METROPOLITAN GOVERNMENT OF NASHVILLE AND DAVIDSON COUNTY

STAFF RECOMMENDATION
612 Monroe Street
February 19, 2014

Application: New construction-infill (Multiple Structures)
District: Germantown Historic Preservation Zoning Overlay
Council District: 19
Map and Parcel Number: 08209003400
Applicant: John Root, Architect
Project Lead: Sean Alexander, sean.alexander@nashville.gov

ARCHITECTURAL SITE PLAN

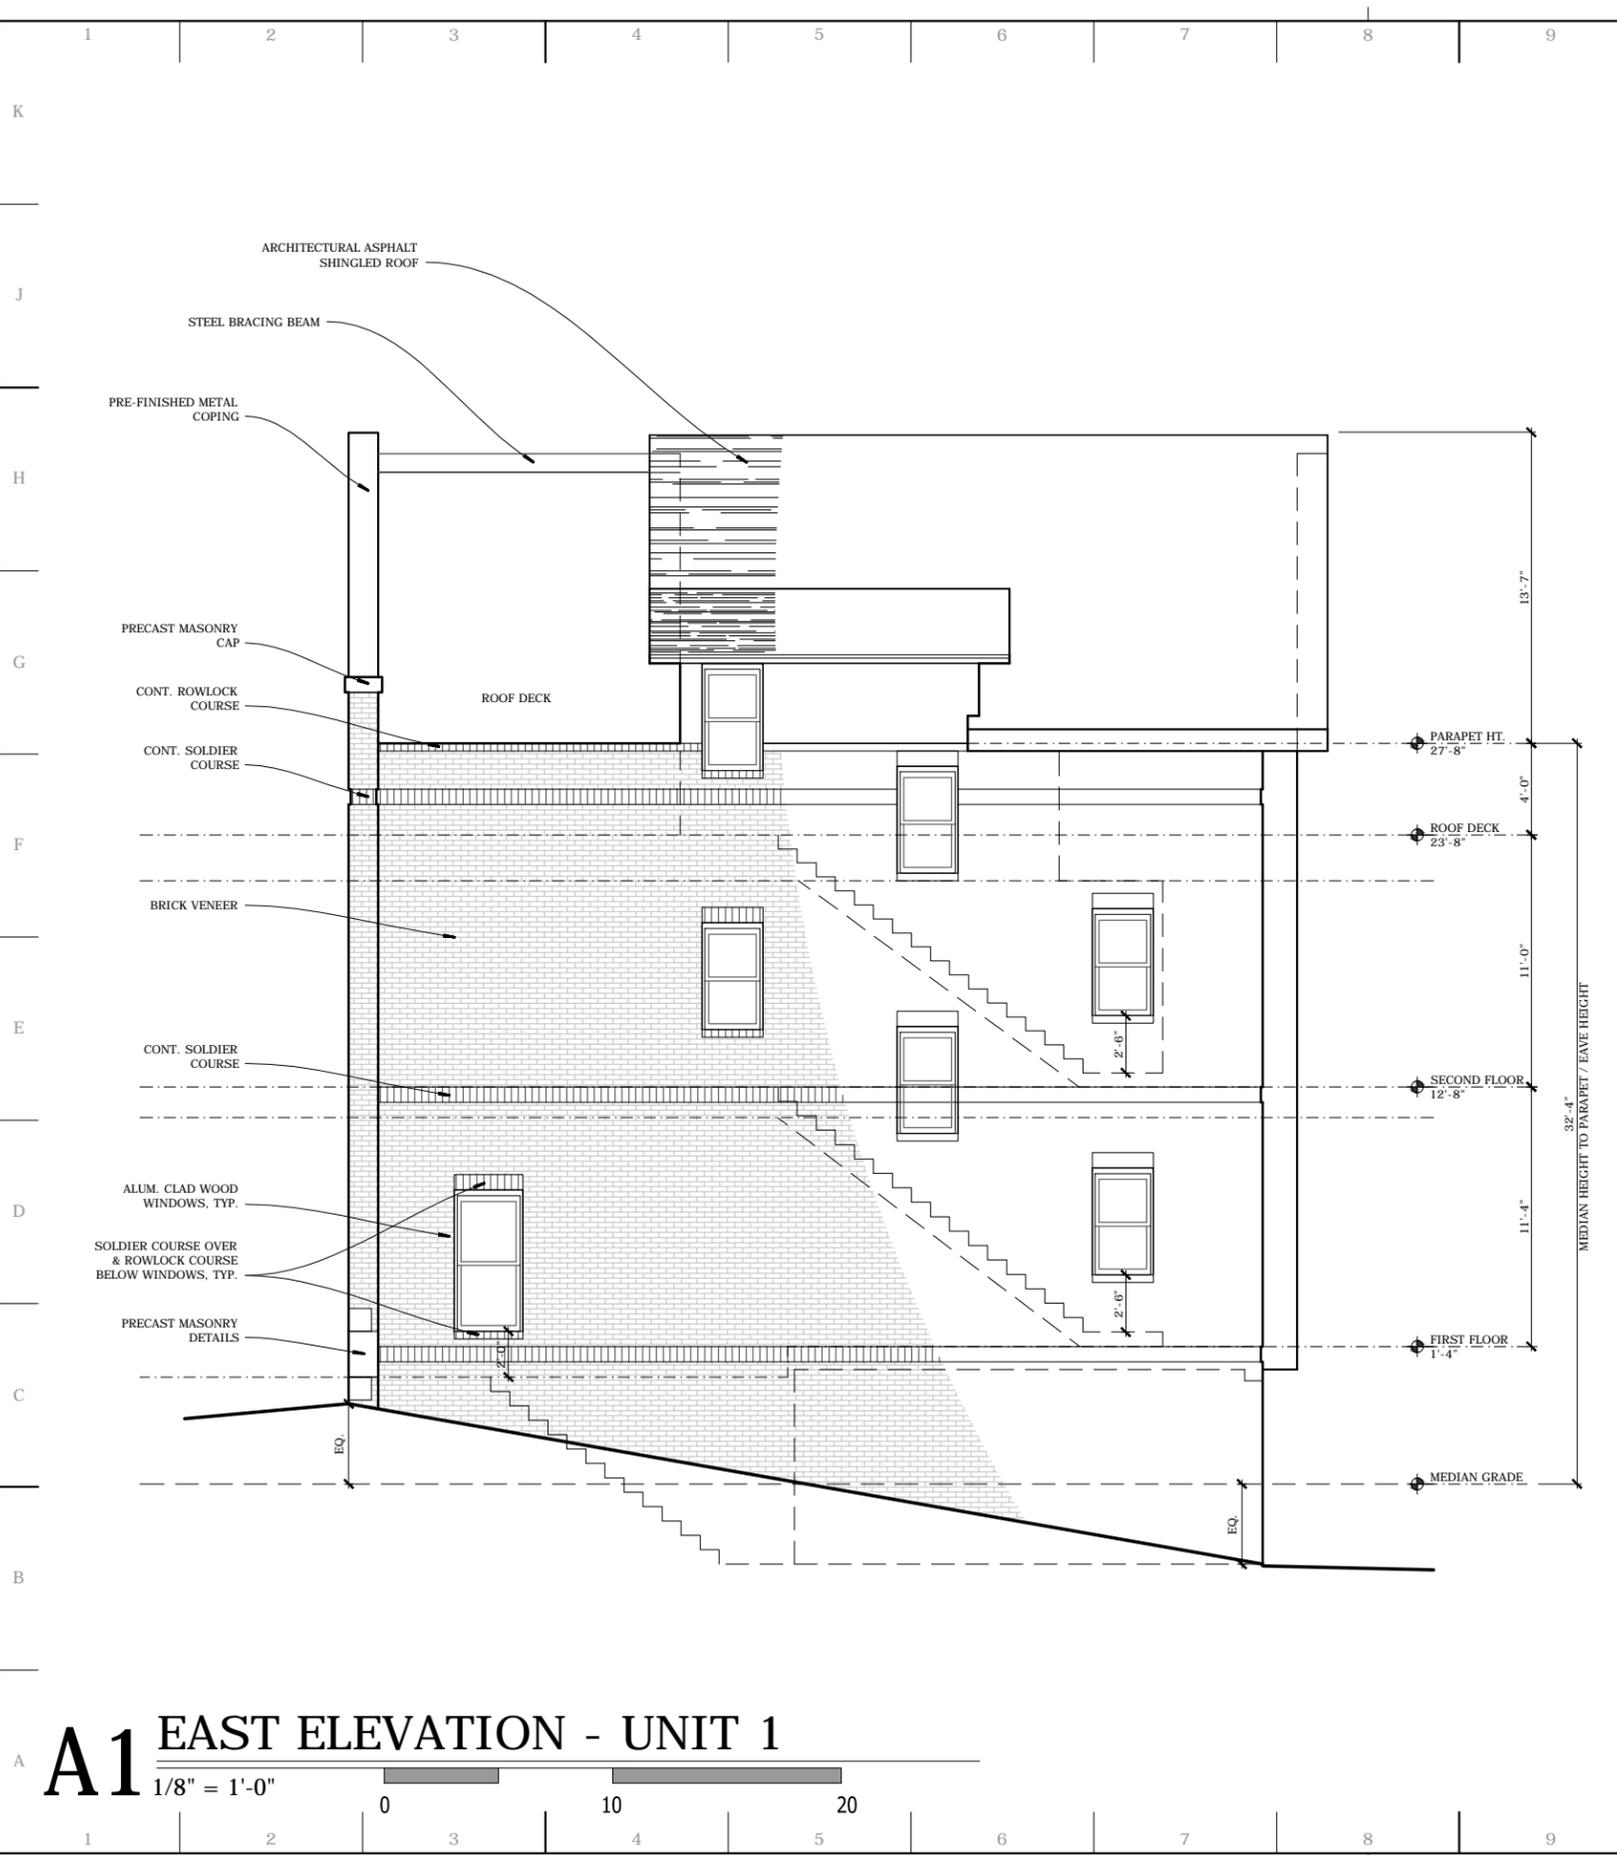
The structures will have six feet (6') of separation between them, with ten foot (10') setbacks from the side property boundaries. The development puts the single-family structures (Units 1, 2, 8) with deeper front setbacks near the edges to be compatible with the adjacent houses and the two-family structures (Units 3-4, 6, 7) with shallower setbacks closer to the corner. This helps the proposed development to maintain the established rhythm of the street and to transition more appropriately way from the historic context toward the corner, which meets guideline 2.2.1.

The structure at the rear of the lot (Unit 9-10) will also have a ten foot (10') side setback and an eighteen foot (18') setback from the alley. This structure will be accessed by a shared interior driveway but would not have a visible connection to engage the street. Staff recommends, as a condition of approval, that walkways be added from the rear units to one or both streets. With appropriate connection to the street, staff finds that the

- Walkways be added to connect the building at the rear of the lot to the street;
- That the front doors be at least half glass;
- That windows are added to the side elevations of the single-family buildings (Units 1, 2, 8);
- That the roof of the corner building (Unit 5) be revised to be more cohesive and not open at the corner;
- The location of HVAC units and other utilities, as well as the material of the driveway and other paving, fences, walls, exterior lights, and other appurtenances are approved by Staff.

EXTERIOR ELEVATIONS - UNIT 1
 REV: DATE: DESC:
 0 02.03.14 MIZC SUBMISSION

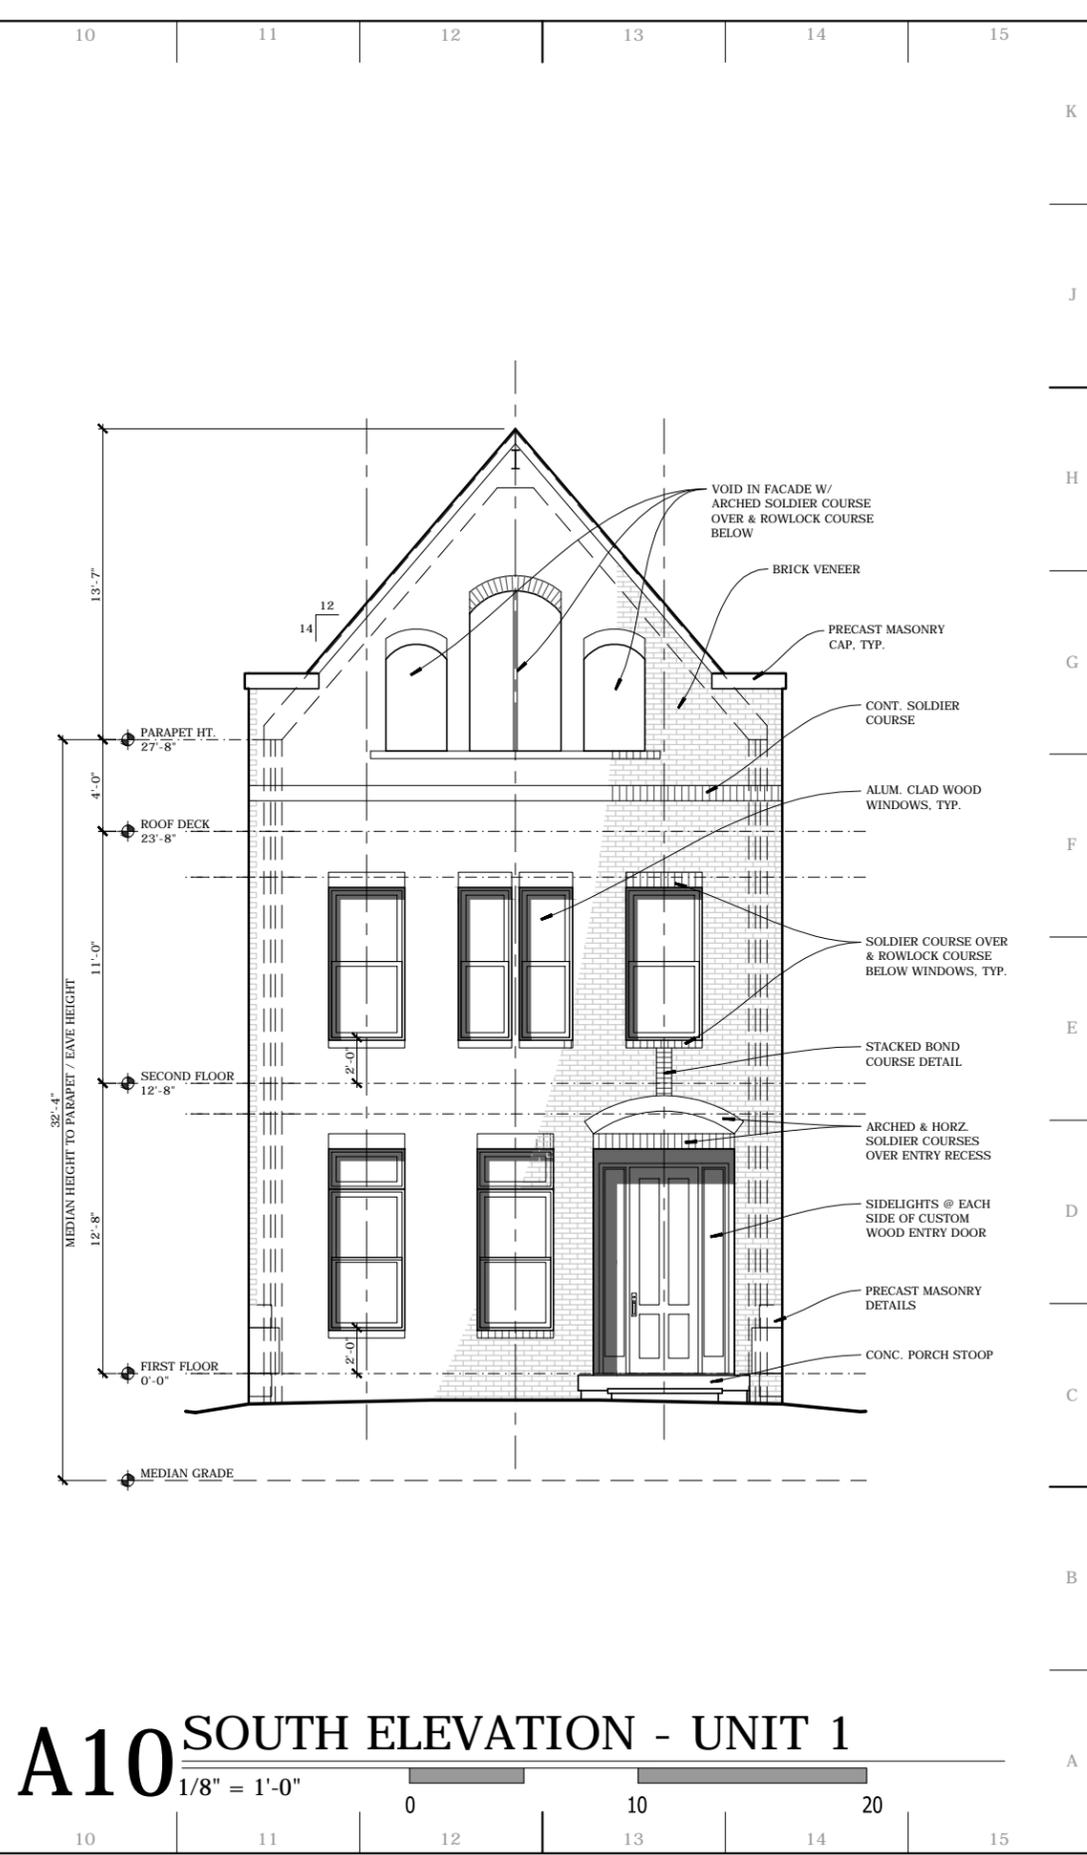
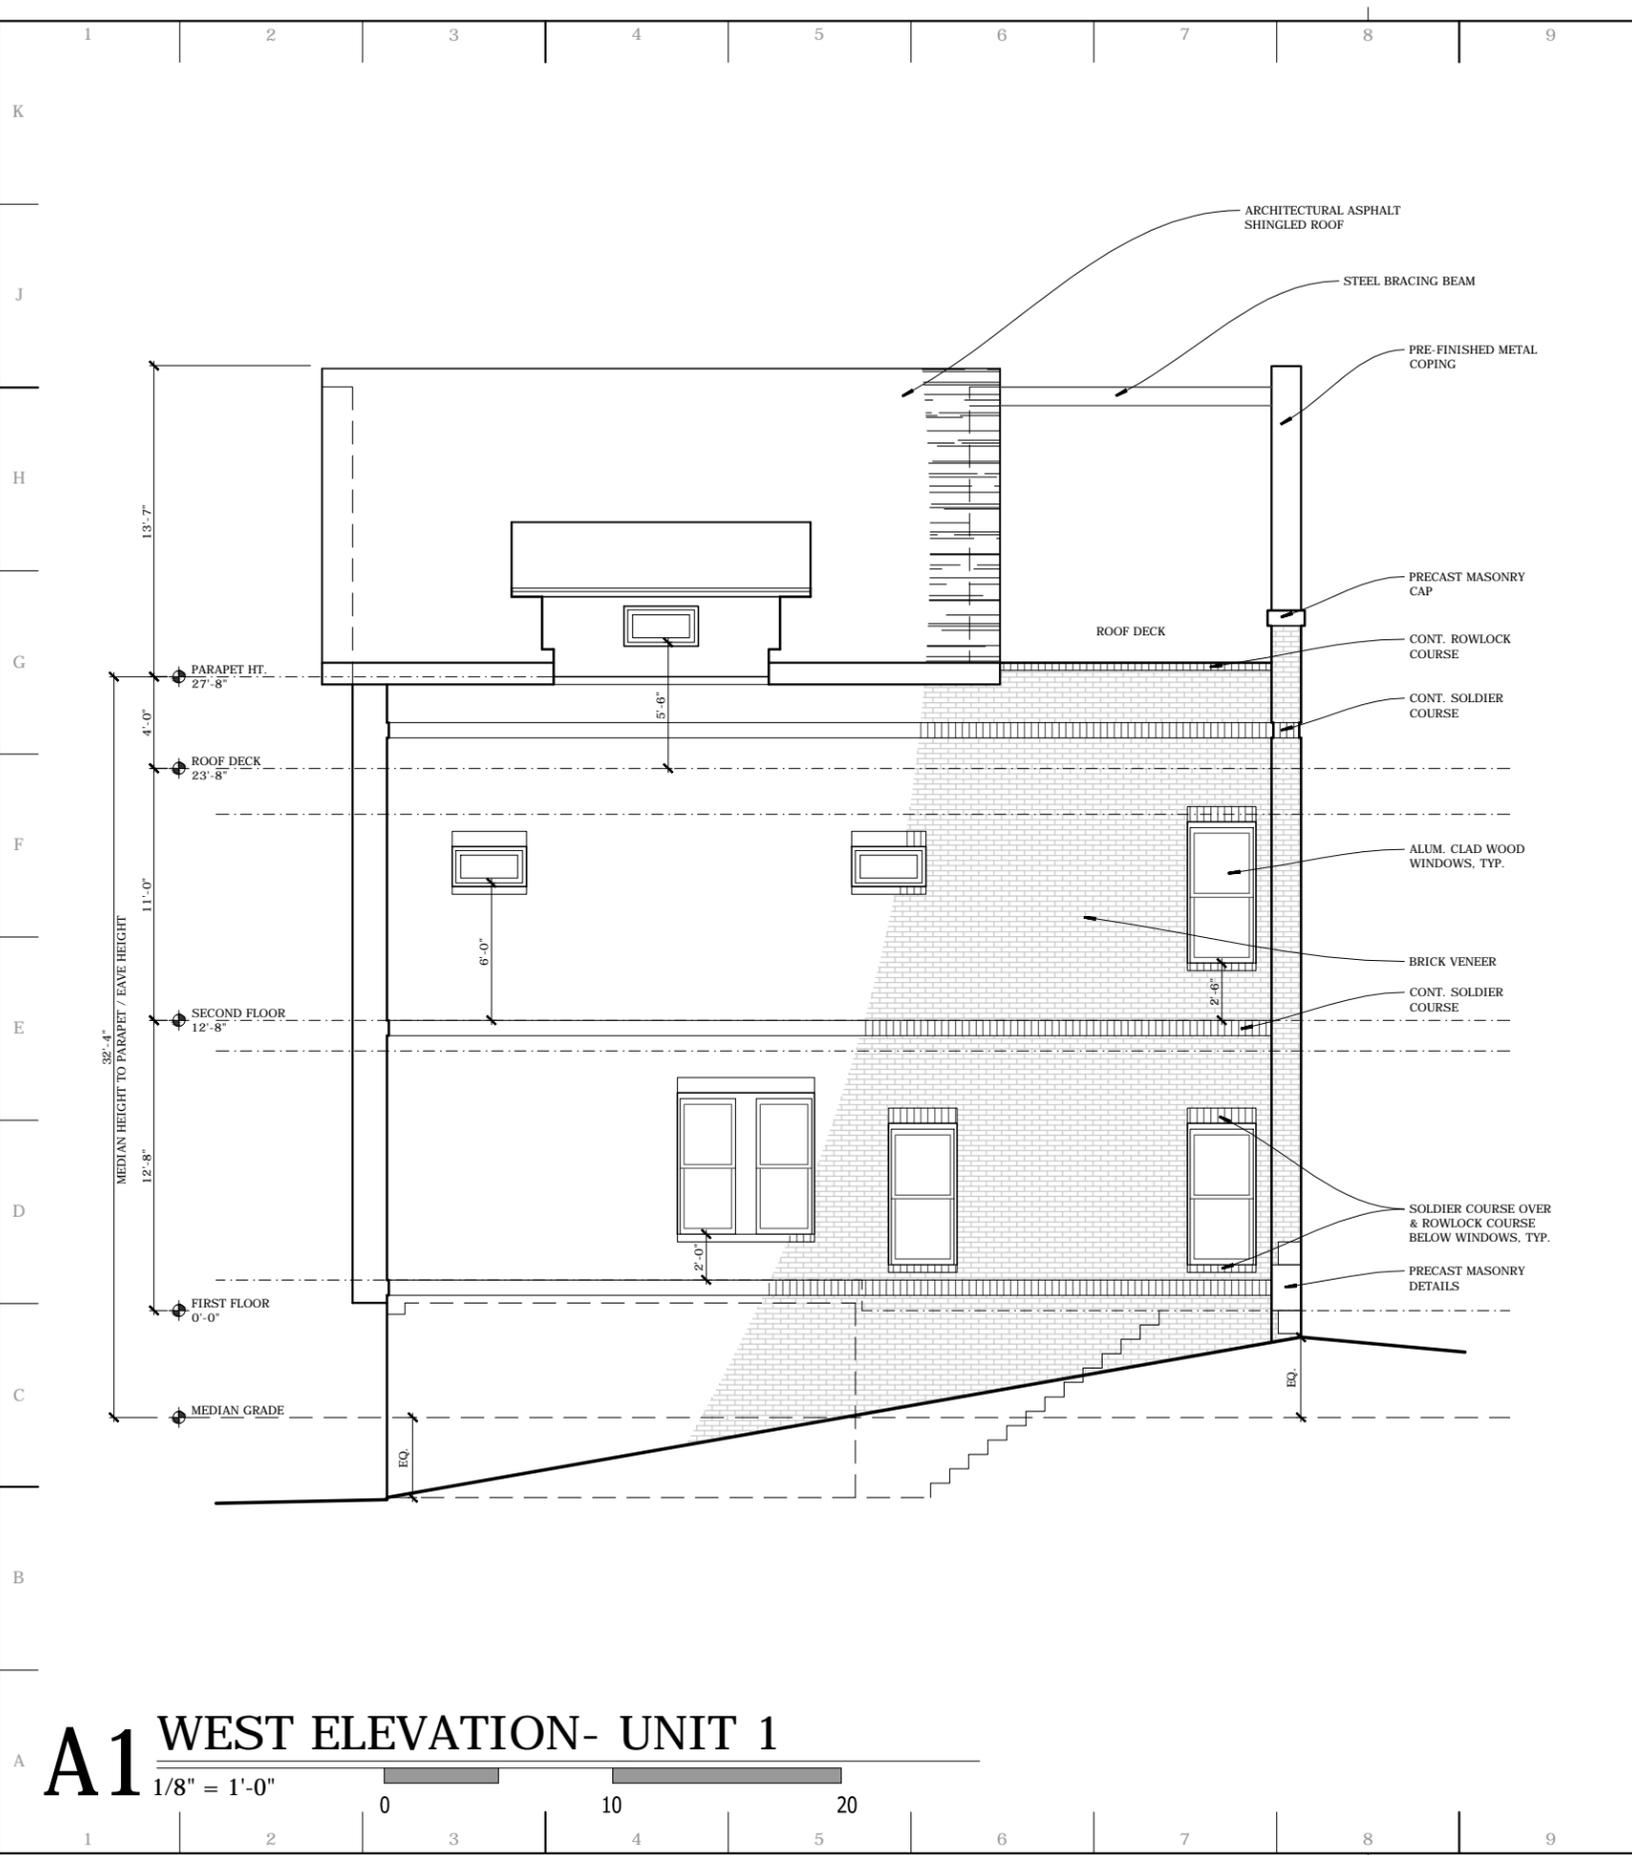
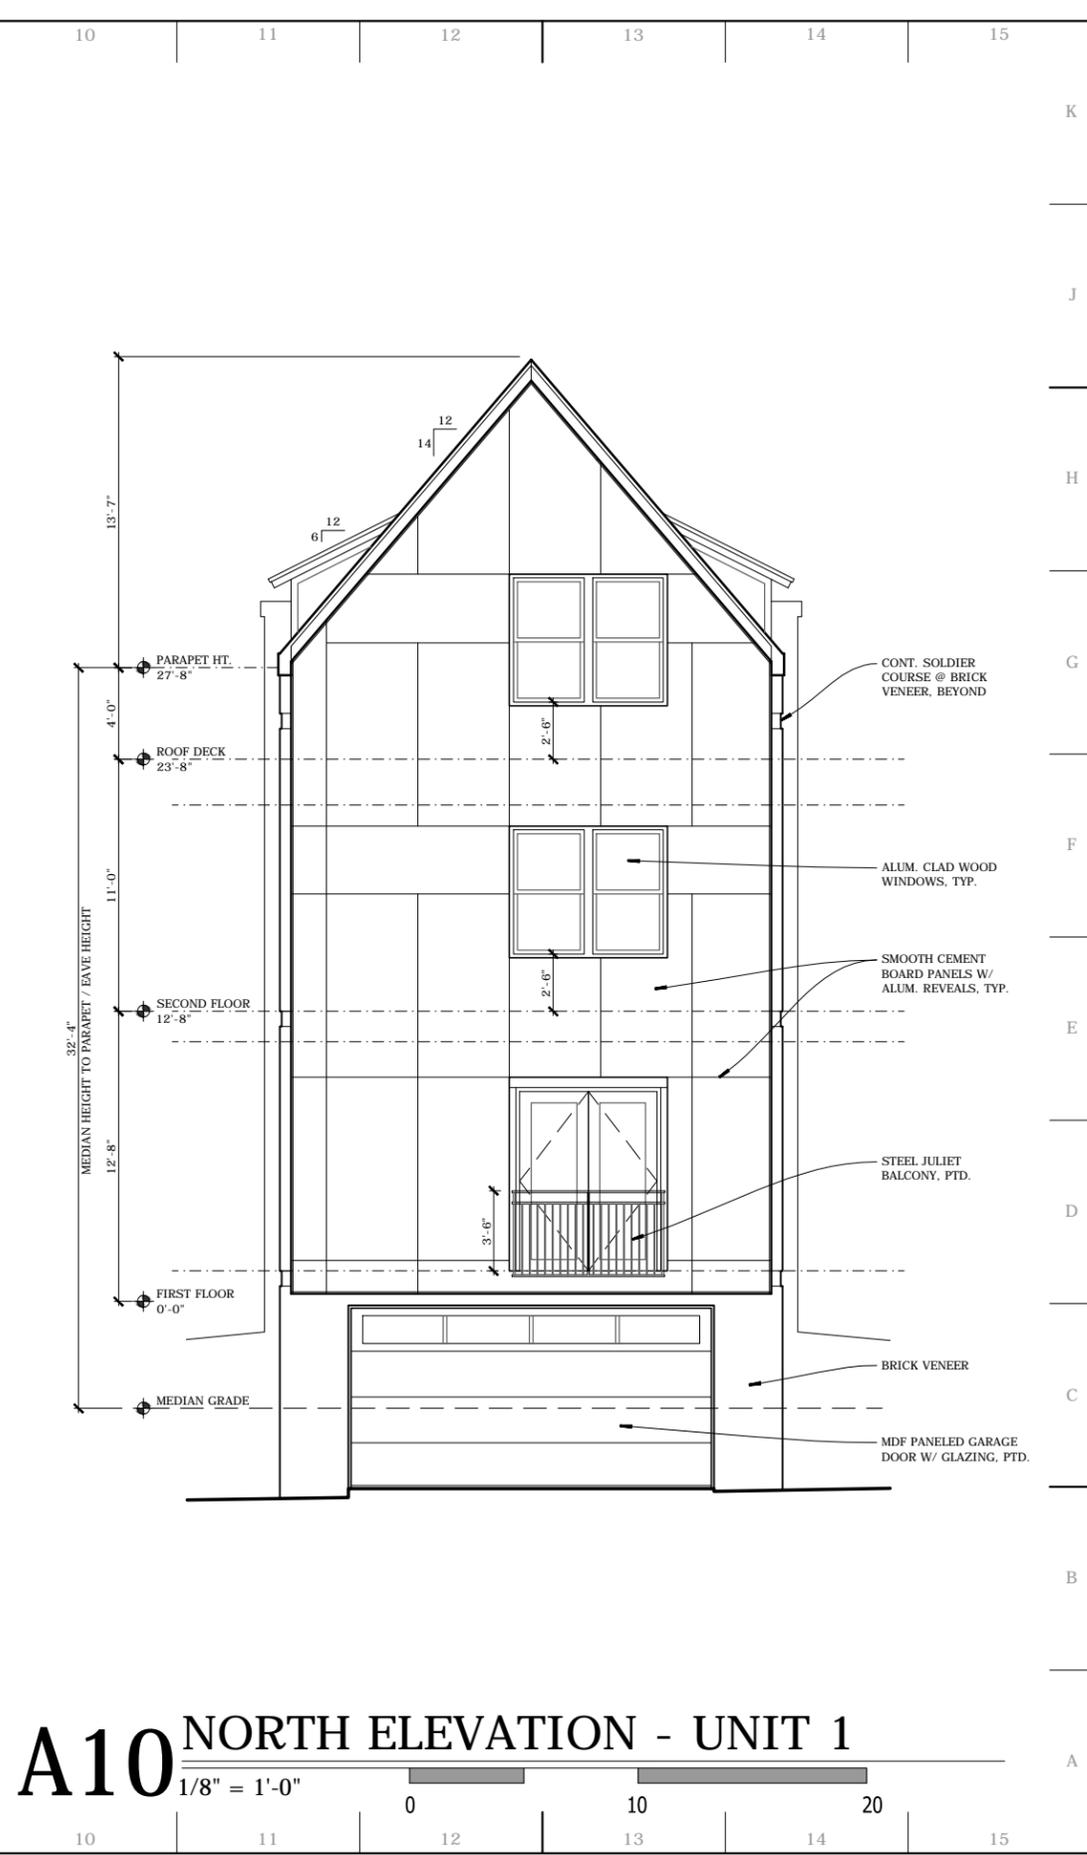
The windows are all vertically oriented and are generally taller on the first story than the second, as is typical of the proportions of windows historically. The numbers and locations of windows on the front elevations are compatible with historic buildings, as well as on the side elevations of the two-family structures (Units 3-4 and 6-7). The single-family structures (Units 1, 2 8), however, would have a portion of uninterrupted wall space greater than fifteen feet (15') toward the front of the second story, which is not compatible with historic houses. With an additional window in this location, staff finds that the proposal will meet guideline 2.6
